Tuesday, 29 April 2014

NOTIFICATION IN TERMS OF THE NATIONAL WATER ACT (ACT NO. 36 OF 1998) FOR THE PROPOSED EXXARO BELFAST PROJECT SITUATED ON VARIOUS PORTIONS OF THE FARMS ZOEKOP 426JS, LEEUWBANK 427 JS AND BLYVOORUITZICHT 383 JT IN THE MAGISTERIAL DISTRICT OF BELFAST IN MPUMALANGA

Figure 1: Updated site locality plan

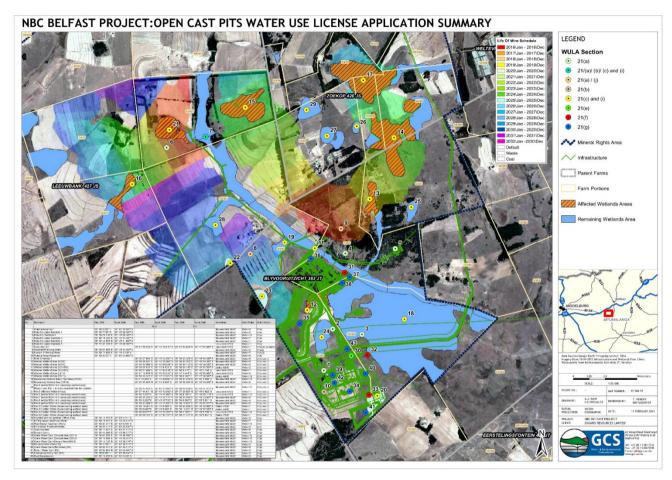
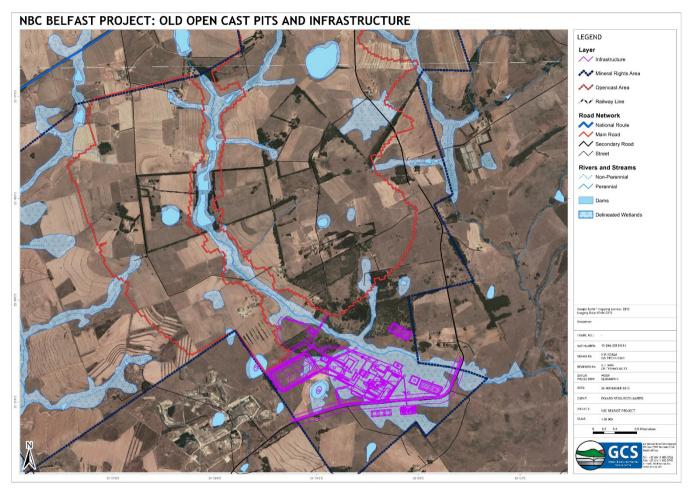
Following the approval of additional funds, Exxaro undertook to revise the Belfast project block plan as per DWA's recommendations. Please refer to Appendix B and Figure 1 (after scenario) for the updated site locality plan compared to the original locality plan (Appendix C and Figure 2) (before scenario). As indicated in Appendix B/Figure 1 the plant area and associated infrastructure has now been designed outside of the wetland areas. Some minor parts of the proposed infrastructure still remains within 500m of the wetland which will still be applicable as a Section 21 c & i water use. Refer to Appendix D for the updated water use table, water balance diagram and water use map.
